# UNITED STATES PATENT AND TRADEMARK OFFICE

APPLICATION NO.	FILING DATE	FIRST NAMED INVENTOR	ATTORNEY DOCKET NO.	CONFIRMATION NO.
10/072,247	10/23/2001	Daniel J. Cook	39726/29361	4051

<b>Office Action Summary</b>	Application No.	Applicant(s)	
	10/072,247	COOK, DANIEL J.	
	Examiner	Art Unit	
	Mital B. Patel	3743

## **DETAILED ACTION**

**FIG. 1**

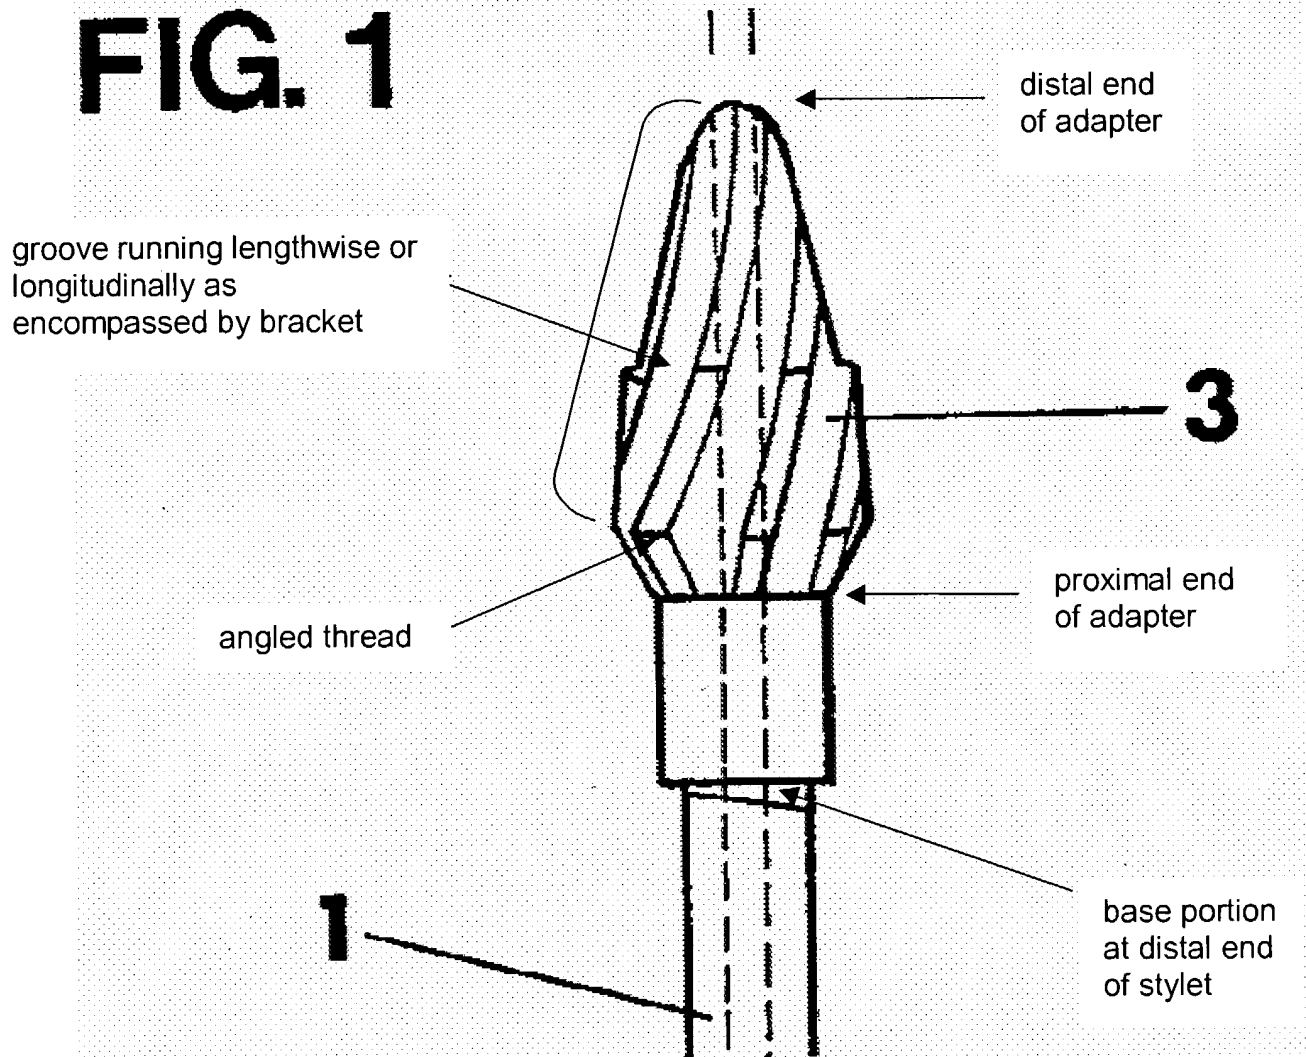
10. **As to claim 6**, DiPietropolo teaches an endo-tracheal tube retainer wherein an exterior surface of the connection adapter 3 comprises a plurality of longitudinal grooves

(Please see Fig. 1 attachment below; Also note that longitudinal is defined in Merriam-Webster's Collegiate Dictionary, 10<sup>th</sup> Ed. as placed or running lengthwise and the Examiner considers DiPietropolo to teach grooves running lengthwise on the adaptor from one end lengthwise to the other end; furthermore, Applicant recites longitudinal grooves on an exterior surface and does not recite longitudinal grooves running along the entire length of the exterior surface of the adaptor) permitting passage of air and fluids past the endo-tracheal tube retainer after insertion within an endo-tracheal tube; and a plurality of threads angled (See Fig. 1 attachment below) to facilitate insertion of said endo-tracheal tube retainer within an endo-tracheal tube, but hindering withdrawal of said endo-tracheal tube retainer from said endo-tracheal tube (Please note that given the structure the device is inherently capable of performing the functions set forth).

11. As to claim 8, DiPietropolo teaches an endo-tracheal tube retainer wherein the longitudinal grooves are equi-spaced around the connection adapter 3 exterior surface (See Fig. 1 attachment below).

12. As to claim 9, DiPietropolo teaches an endo-tracheal retainer wherein there are at least four longitudinal grooves (See Fig. 1 attachment below; please note only 3 are shown, the remaining grooves being on the other side of the adapter).

insertion within an endo-tracheal tube; and a plurality of threads angled (**See Fig. 1 attachment above**) to facilitate insertion of said endo-tracheal tube retainer within an endo-tracheal tube, but hindering withdrawal of said endo-tracheal tube retainer from said endo-tracheal tube (**Please note that given the structure the device is inherently capable of performing the functions set forth**).
